BIDDERS BULLETIN

PROJECT: First National Bank Drive Through
North Platte, Nebraska

BB-2

PROJECT #: 11-0794

TRASH ENCLOSURE

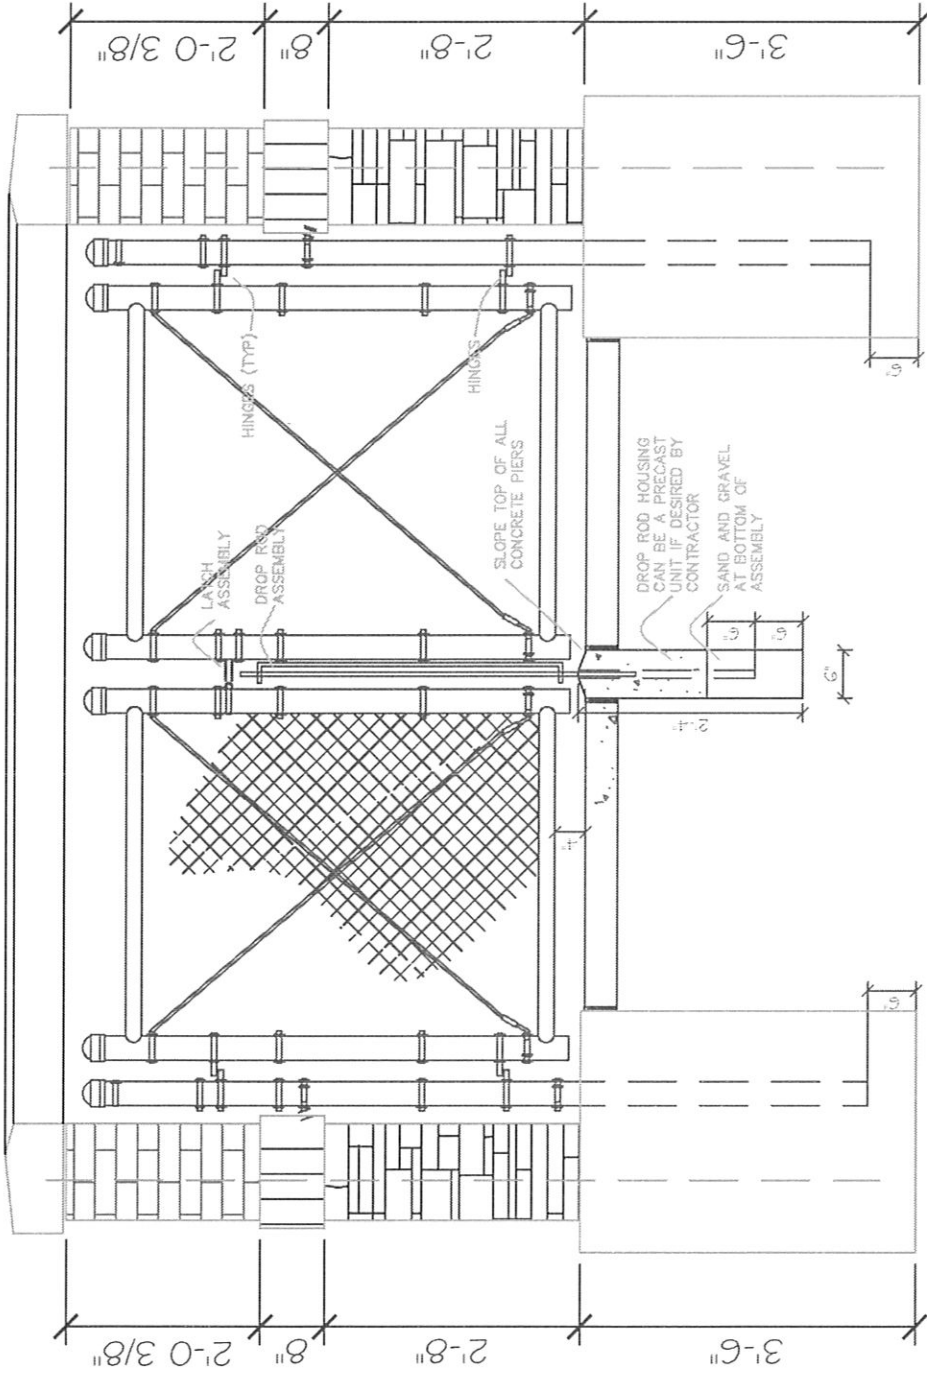
1. Refer to the attached details D-1 through D-6 for fence information, trash enclosure, gate assembly and flag pole details.
1. Front column details will remain framed as wood, not steel framing.

FENCE DETAIL
 SCALE: 1/2" = 1' - 0"

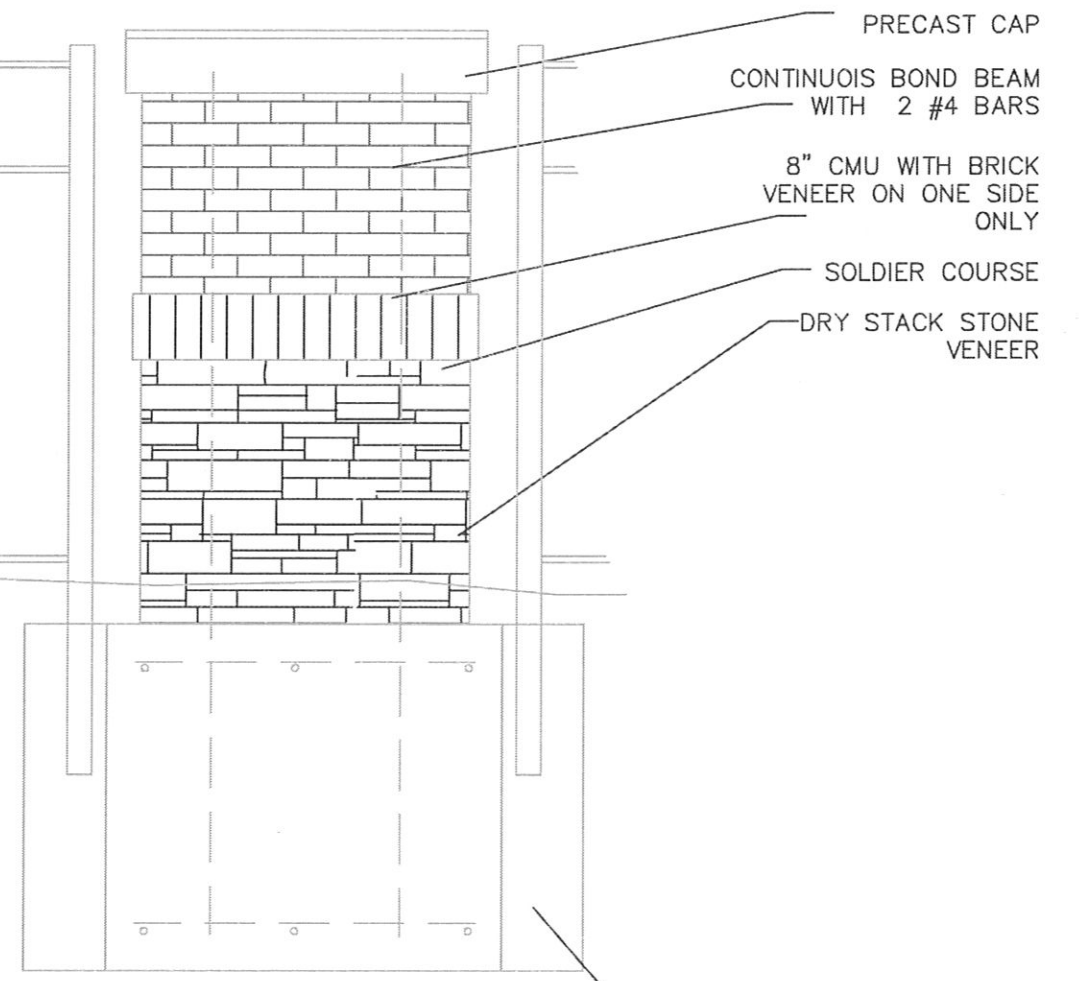
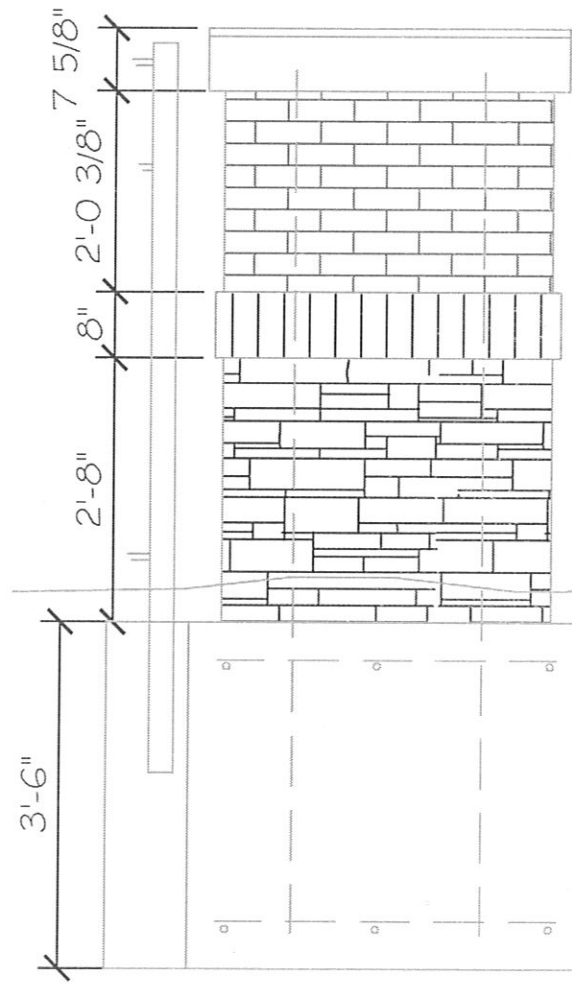
1. Refer to attached site plan for fence location only. Fence design has been changed to alter the amount and size of the masonry fence.
